PUBLIC HEARING MEMORANDUM

SUBJECT: **Petition #201-17**, petition for SPECIAL PERMIT/SITE PLAN APPROVAL to construct a three-story, 36 feet in height mixed use building with a floor area ratio of 1.49, allow waivers to the parking requirements, and waivers to the lot area per unit requirements at **386-394 Watertown Street**, Ward 1, Nonantum, on land known as SBL 14, 14, 35; 14, 14, 38; and 14, 14, 38 containing approximately 9,542 sf of land in a district zoned Business 1. Ref: Sec. §4.1.2.B.3, §4.1.3, §5.1.4, §5.11, 5.11.15.A and §7.3.3, of Chapter 30 of the City of Newton Rev Zoning Ord, 2015.

ZONING REVIEW MEMORANDUM

MEMORANDUM

B. Site Design

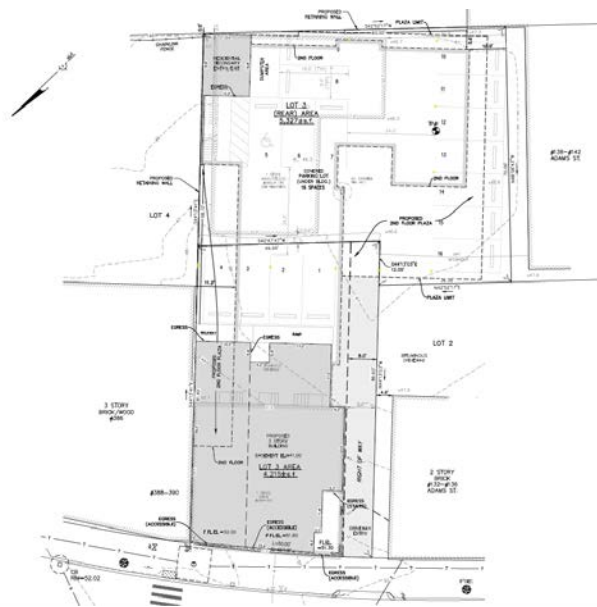
The petitioner is proposing to raze the existing structures and construct a three-story mixed use building with two stories of residential space above two ground floor commercial uses and parking beneath the building. The footprint of the building is arranged in the shape of an “L”, to mirror the layout of the two lots. The structure will consume much of the lot, but retain the eight foot side setback to the right. As proposed, the structure is approximately 35 feet tall, totaling 14,204 square feet. The site plan indicates there are retaining walls proposed along the southern and eastern boundaries, but no dimensions are given. Staff suggests the petitioner clarify the height of the walls at a Working Session.

*Topographic Site Plan
Newton, MA
Showing Proposed Conditions at #386-394 Watertown Street
Prepared by: VTP Associates Inc.
Dated: June 12, 2017*

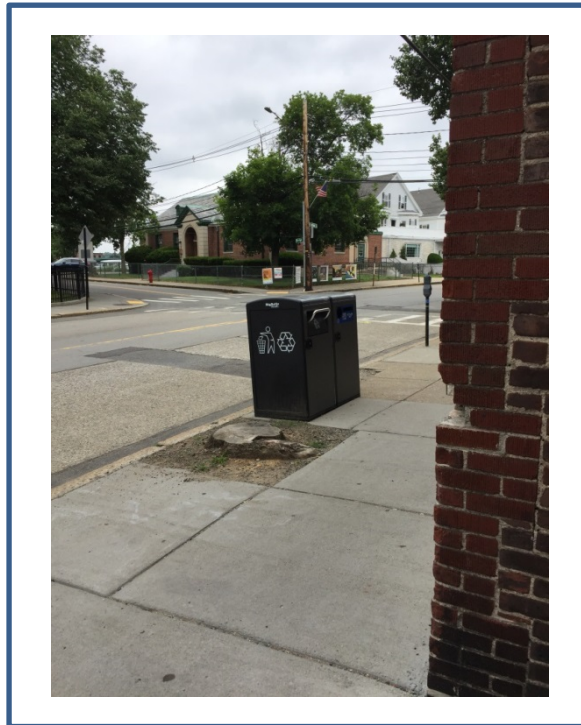
The site is relatively flat and is approximately 69% impervious surfaces (buildings & pavement). The engineer of record has designed a stormwater collection and infiltration system to substantially reduce runoff from the site, and in conformance to the Department of Environmental Protection (DEP) and DPW Stormwater Policy. An operations and maintenance plan is needed to address long-term maintenance for the proposed infiltration system.

A turning template plan is needed to demonstrate the maneuverability of vehicles entering, parking and exiting the proposed covered parking lot; it should be a separate plan showing the support columns from the plaza above and building's structural supports that will be within the footprint of the parking area. Since the parking is on grade but beneath the plaza and residential units above, the Fire Department may require a fire suppression system for the covered parking spaces.

Egress from the site may be difficult due to limited sight distance of the existing buildings; for pedestrian safety, it may be prudent to install a warning light & audible alarm to warn pedestrians when vehicles are exiting the site.

The engineer of record needs to clarify how recycling and trash will be removed from the site since the proposed location of dumpster is beneath the building. Finally how and where will US mail be delivered, will it be a centralized mail box for the entire building?
